INDIAN POINT NUCLEAR GENERATING UNIT NO. 3

AMENDMENT TO FACILITY OPERATING LICENSE

Amendment No. 39
License No. DPR-64

ATTACHMENT TO LICENSE AMENDMENT NO. 39

FIGURE 6.2-1

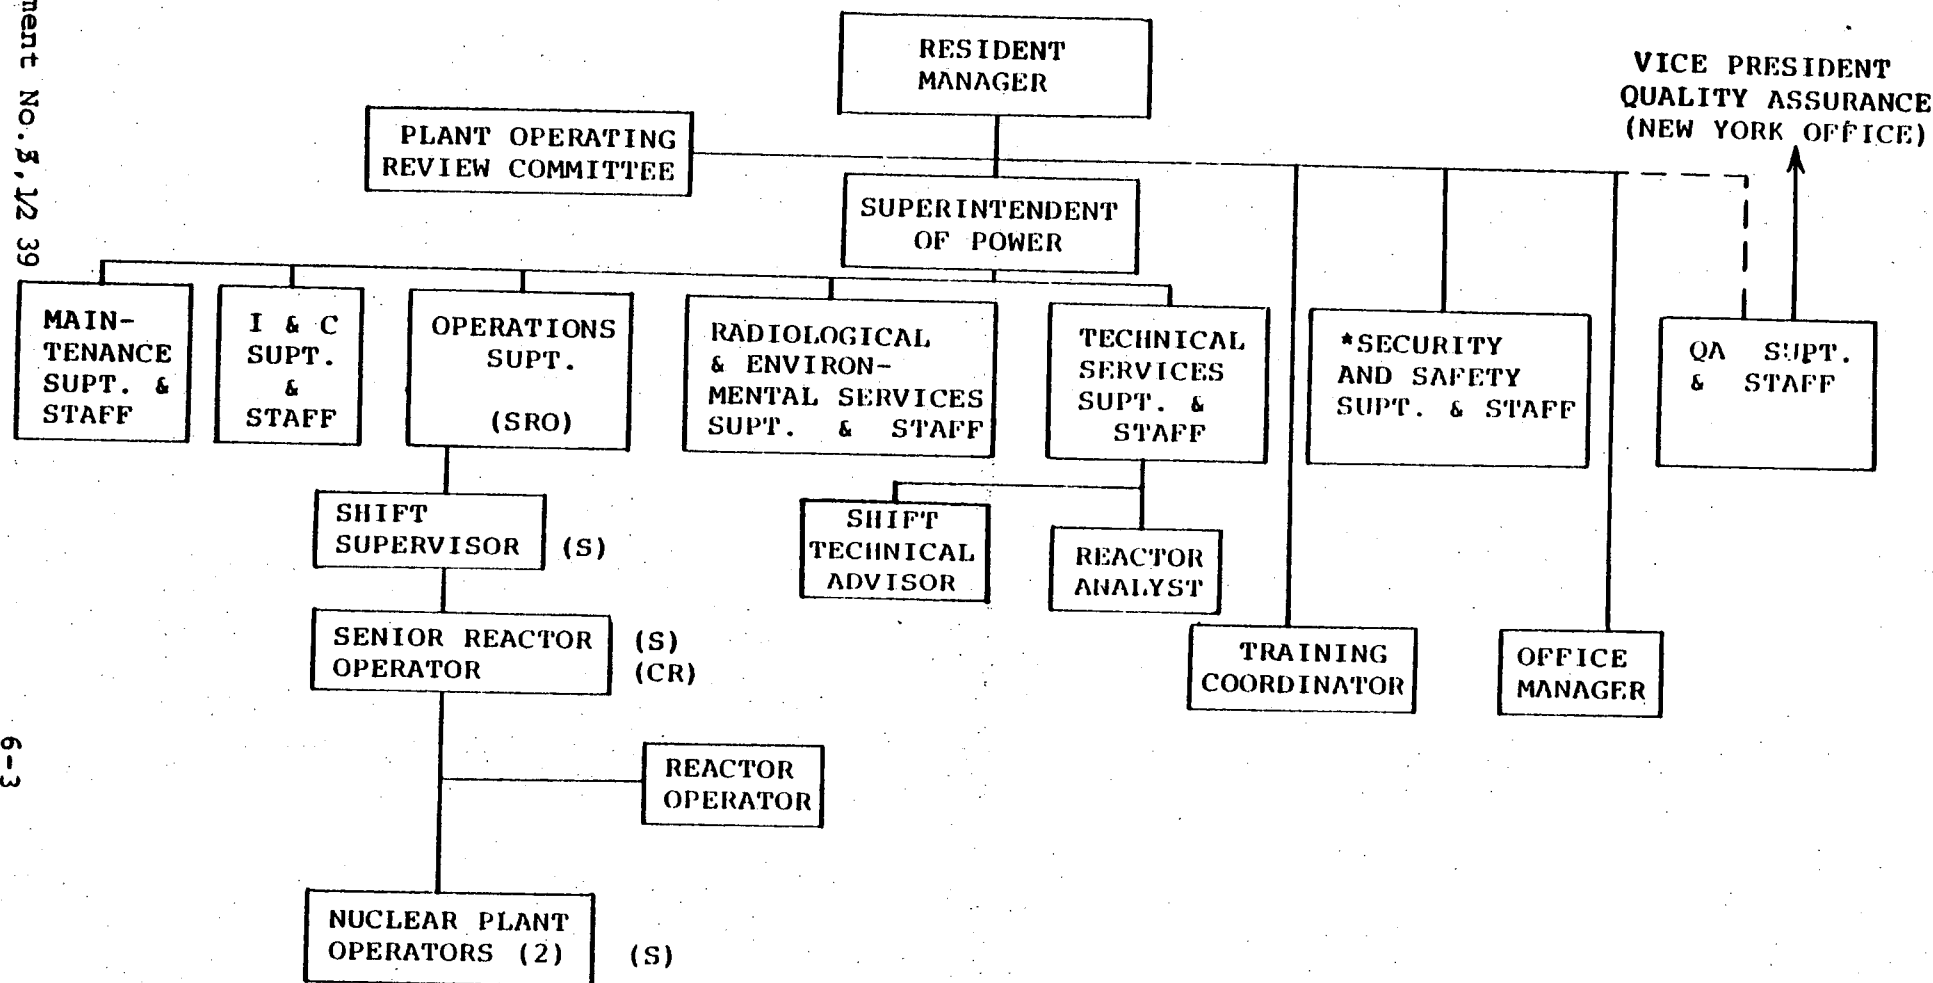
6.1.1 The Resident Manager shall be responsible for overall facility operation. During periods when the Resident Manager is unavailable, the Superintendent of Power will assume his responsibilities. In the event both are unavailable, the Resident Manager may delegate this responsibility to other qualified supervisory personnel. The Resident Manager reports directly to the Sr. Vice President Nuclear Generation, as shown in Fig. 6.2-1.

6.2.1 The offsite organization for plant management and technical support shall be as shown on Figure 6.2-1.

†The Senior Vice President Nuclear Generation is responsible for administering the fire protection program.

*The Director of Safety and Fire Protection is the off-site management position responsible for assessing the effectiveness of the fire protection programs by conducting reviews and audits.
